**FINAL PRODUCT/PROCESS CHANGE NOTIFICATION #16565**Generic Copy

**Issue Date:** 12-Oct-2011**TITLE:** LQFP/TQFP Mold Compound and Epoxy Change in ATP1**PROPOSED FIRST SHIP DATE:** 12-Jan-2012**AFFECTED CHANGE CATEGORY(S):** Mold Operation – New Mold Compound**FOR ANY QUESTIONS CONCERNING THIS NOTIFICATION:**Contact your local ON Semiconductor Sales Office or Sarah Sanico<[ffxxh@onsemi.com](mailto:ffxxh@onsemi.com)>**SAMPLES:** Contact your local ON Semiconductor Sales Office**ADDITIONAL RELIABILITY DATA:** AvailableContact your local ON Semiconductor Sales Office or Sarah Sanico<[ffxxh@onsemi.com](mailto:ffxxh@onsemi.com)>**NOTIFICATION TYPE:**

Figure 1. Acoustic Microscopy Image prior Moisture Resistance test.

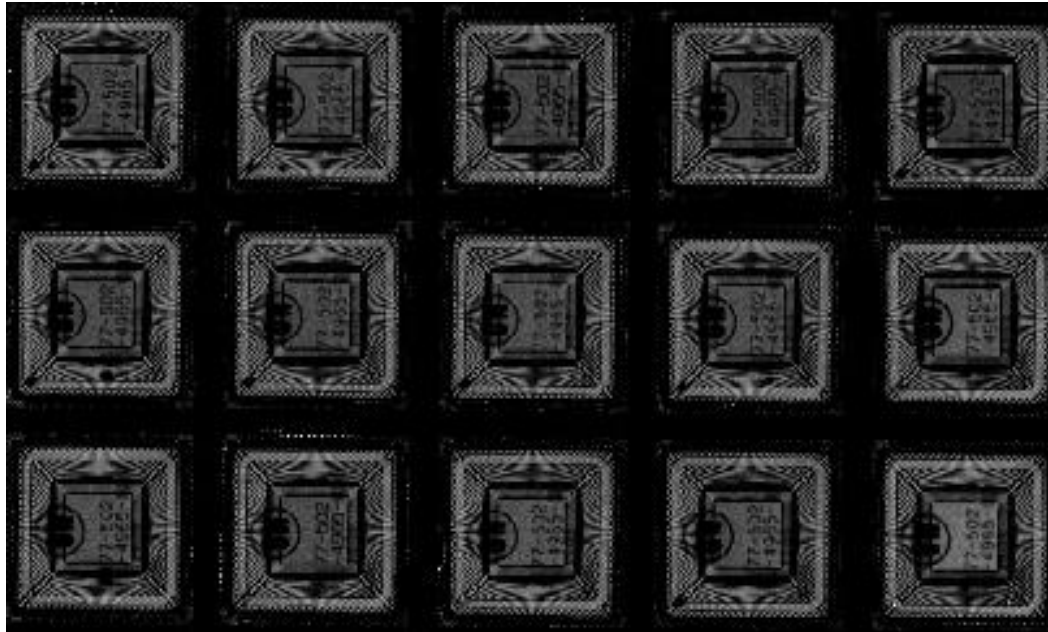
TEST	CONDITIONS	CHECKPOINTS	RESULT
Moisture Preconditioning • Bake • Humidity Soak • Reflow	125°C 30°C / 60% RH 225°C	21 hrs 192 hrs 3 cycles	PASSED
Scanning Acoustic Microscopy	Not Applicable	Pre and Post MSL	PASSED (see Figure 1 & 2)
Preconditioning Temperature Cycling	-55°C / 125°C	100 cycles	PASSED
Temperature Cycling	-65°C / 150°C	500 cycles	PASSED
Unbiased-HAST	130°C / 85% RH	96 hrs	PASSED
High Temperature Bake	150°	500 hrs. 1000 hrs	PASSED
Bond Pull Test	Not Applicable	Not Applicable	PASSED (see Figure 4)
Bond Shear Test	Not Applicable	Not Applicable	PASSED (see Figure 5)
Electrical Testing	SW2, 125°C	Not Applicable	PASSED
External Visual	Not Applicable	Not Applicable	PASSED (see Figure 6)
Physical Dimension Inspection	Not Applicable	Not Applicable	PASSED
X-ray Inspection	Not Applicable	Not Applicable	PASSED (see Figure 7)
Solderability test	Not Applicable	Not Applicable	PASSED
